## **DEVELOPMENT APPLICATION ASSESSMENT REPORT**

A multipation Number	DA0000/4700		
Application Number:	DA2023/1706		
Responsible Officer: Dean Pattalis			
Land to be developed (Address):	Lot 51 DP 12556, 41 Waratah Parade NARRAWEENA NSW 2099		
Proposed Development:	Demolition works and construction of a dwelling house		
Zoning:	Warringah LEP2011 - Land zoned R2 Low Density Residential		
Development Permissible:	Yes		
Existing Use Rights:	No		
Consent Authority:	Northern Beaches Council		
Land and Environment Court Action:	No		
Owner:	Jennifer Enid Spring		
Applicant:	Jennifer Enid Spring		
Application Lodged:	27/11/2023		
Integrated Development:	No		
Designated Development:	No		
State Reporting Category:	Residential - Single new detached dwelling		
Notified:	01/12/2023 to 15/12/2023		
Advertised:	Not Advertised		
Submissions Received:	0		
Clause 4.6 Variation:	Nil		
Recommendation:	Approval		
Estimated Cost of Works:	\$ 927,131.00

The application seeks consent for the demolition of the existing on-site dwelling and the construction of a new double-storey dwelling.

Figure 1: Southern envelope non-compliance

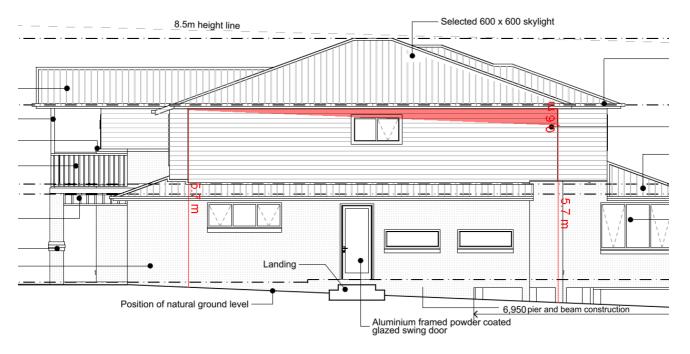
The proposed first floor encroaches the building envelope by a maximum of 0.6m on the southern elevation, as well as 1.1m on the northern elevation.

The southern elevation non-compliance is considered to be minor, with the extent of non-compliance being largely located at the rear portion of the side elevation, therefore ensuring a generally compliant presentation to the street frontage.

Figure 2: Northern envelope non-compliance

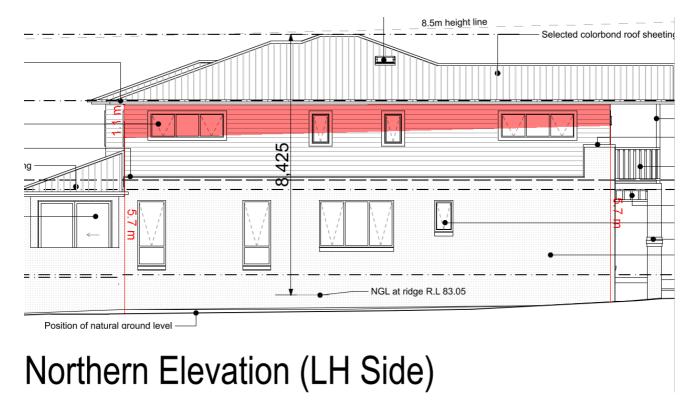
However, the variation to the control on the northern elevation is considered to be excessive and required to be reduced. A suitable condition of consent has been recommended for the setback to the first floor of the development to be increased by 300mm.

The side setback to the northern elevation of the first floor shall be increased by a minimum of 300mm. The northern elevation of the ground floor may remain where it is or increased to be inline with the first floor.
